Appendix E
Material Handling Plan Summary

**Subject: Freeport-McMoRan Chino Mine (Chino)
Pit and Material Handling Plan Update**

MMD COMMENTS ON THE PLAN/COVER LETTER

NMED COMMENTS ON THE MHP

Figure 1 Sampling Comparison

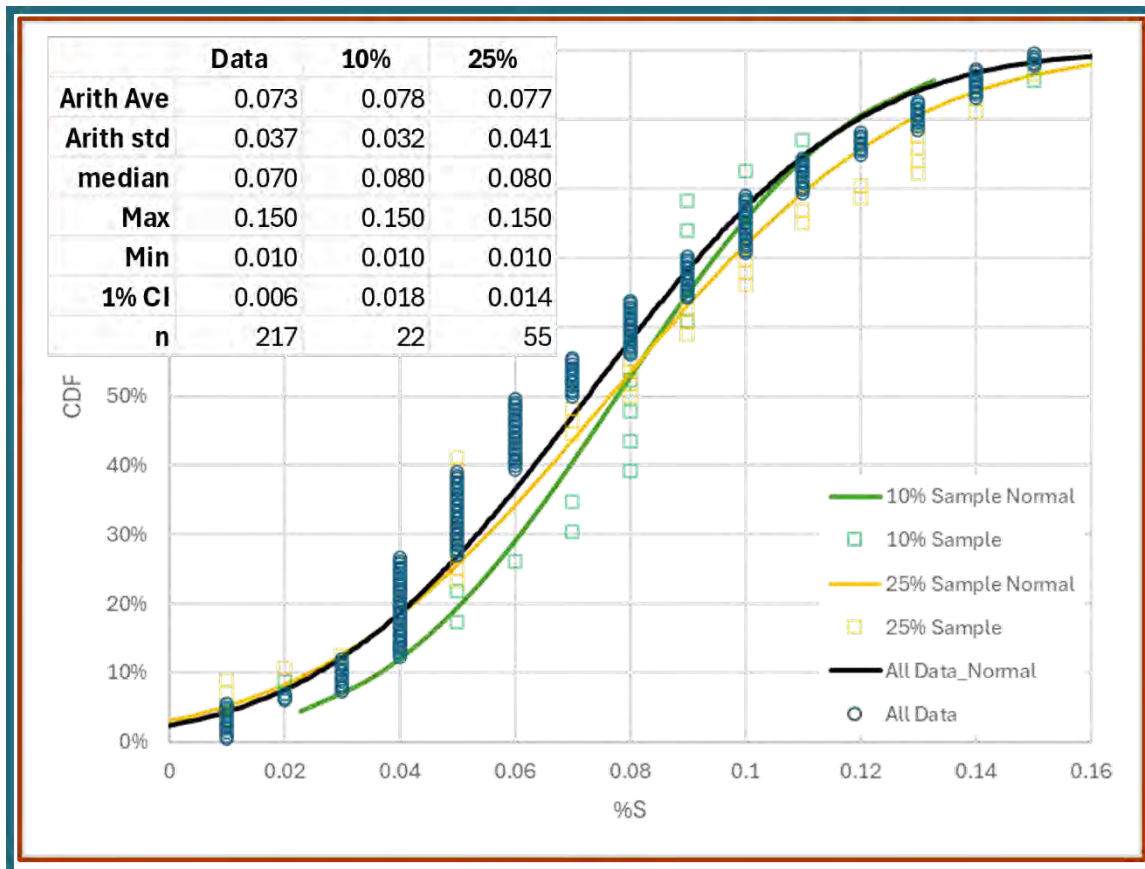
4. *Section 3.3 Suitability Screening Criteria: "Paste pH will be performed on 10 percent of these samples to provide confirmation of the positive relationships observed in the drill hole data."*

Response: The previous 2006 South Pit Materials Handling Plan stated that 25 percent of the samples will provide confirmation. MMD requests a rationale for the decrease from 25 percent to 10 percent.

Chino's primary rationalization for reducing the frequency of confirmation samples is based on the strong correlation showing that samples with percent sulfur below 0.15% consistently have pH above 5.

Chino's second rationalization is displayed by Figure 1, which provides a comparison of three sample populations for percent sulfur less than or equal to 0.15%:

Also shown in Figure 1 are comparisons between parametric statistics assuming a normal distribution. Both the 10% and 25% sampling reproduce parametric statistics close to the data's parametric statistics. Also, there is very little difference in the parametric statistics between the 10% and 25% random sampling populations. Thus, reducing the sampling frequency from 1-in-4 to 1-in-10 will have little effect on testing to verify that the relationship between pH and percent sulfur holds.

CLIENT FREEMPORT-MCMORAN CHINO MINES COMPANY BAYARD, NEW MEXICO	 GOLDER MEMBER OF WSP	PROJECT CHINO MATERIALS HANDLING PLAN					
TITLE PROCESS DIAGRAM FOR PIT MATERIALS HANDLING		DRAWN TS	CHECKED	REVIEWED	DATE 05-11-2021	SCALE N/A	JOB NO. 21466735

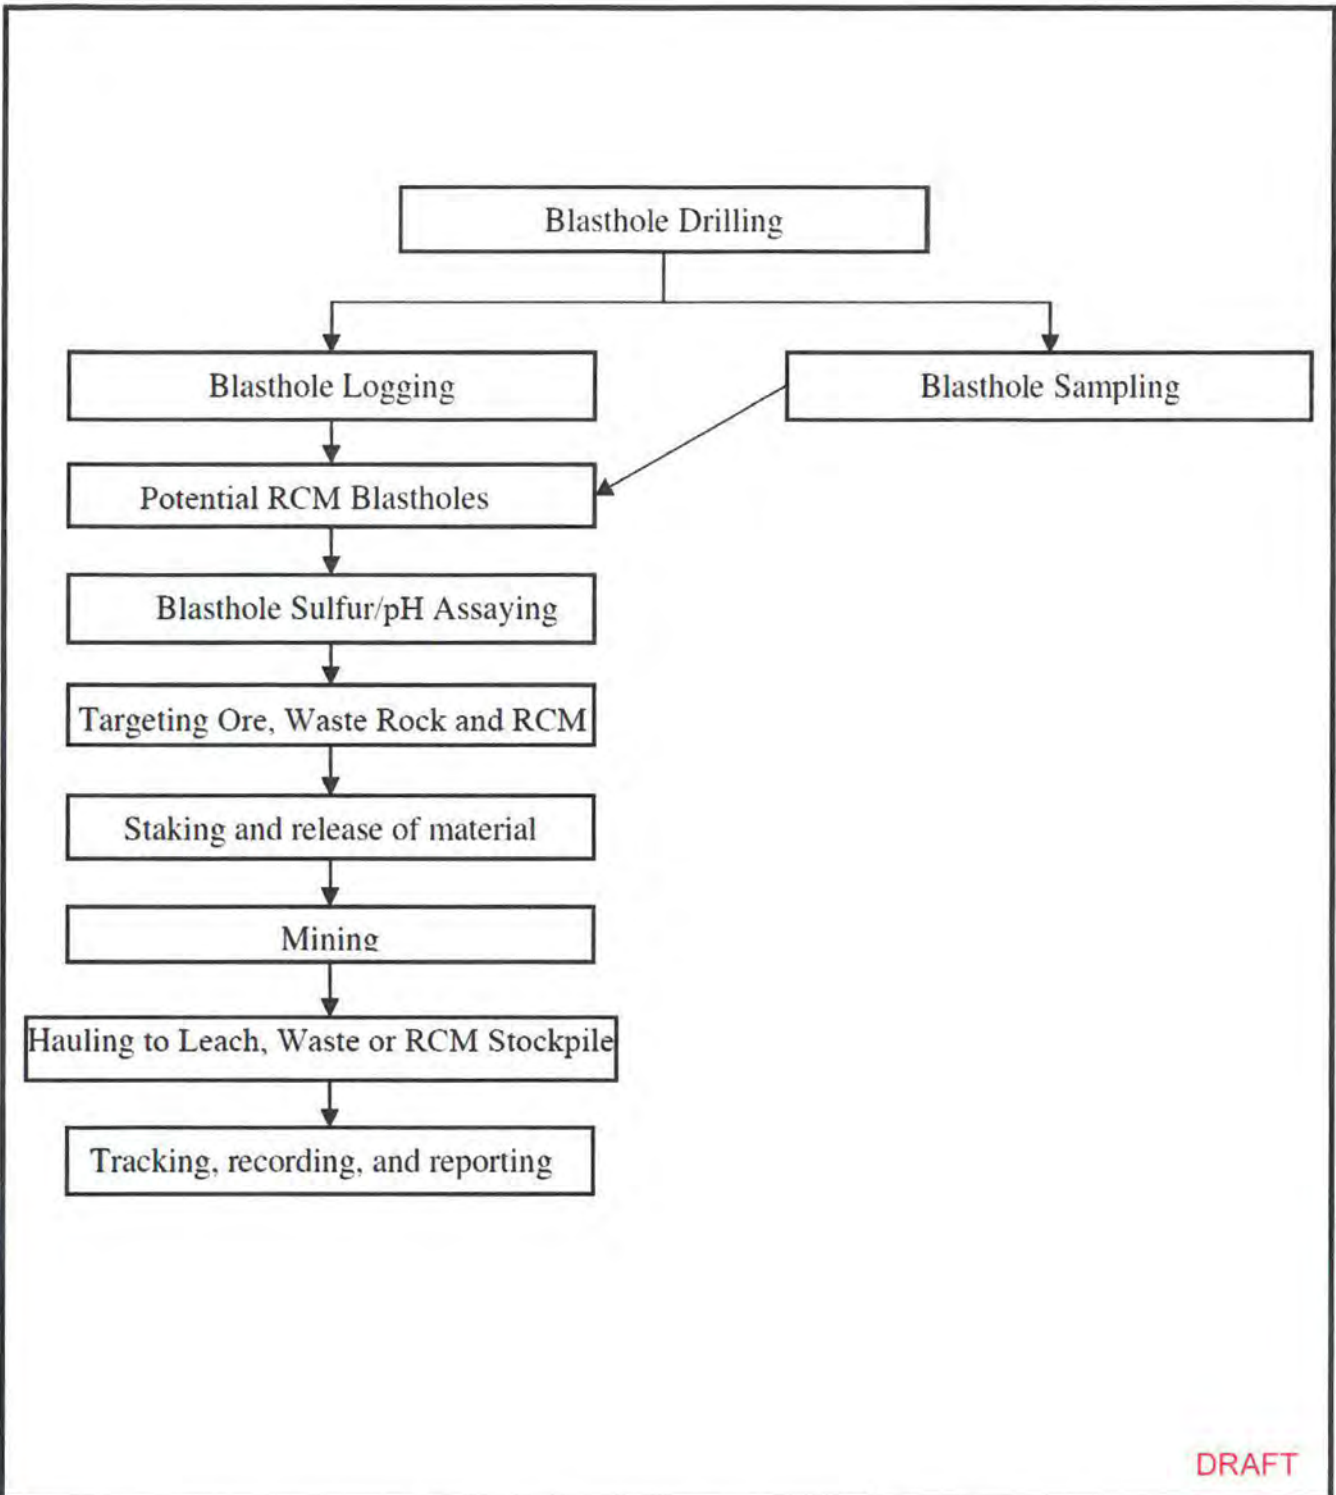
MMD Response: MMD requests a discussion as to whether an adjustment to the reject volume when handling RCM at reclamation will be needed due to the increased diameter of rhyolite from this zone and whether this will need to be accounted for in Chino’s future RCM volumetric calculations.

Chino welcomes a discussion on this topic. Figure 5 in the MHP describes a step “staking and release of material” that denotes to where Chino will haul blasted materials. For the rhyolite that has an inconsistently large fraction, Chino’s geologists will stake this material for release to riprap or waste rock stockpiles rather than RCM stockpiles. This step eliminates the need for accounting for excessively large quantities of boulders in the RCM.
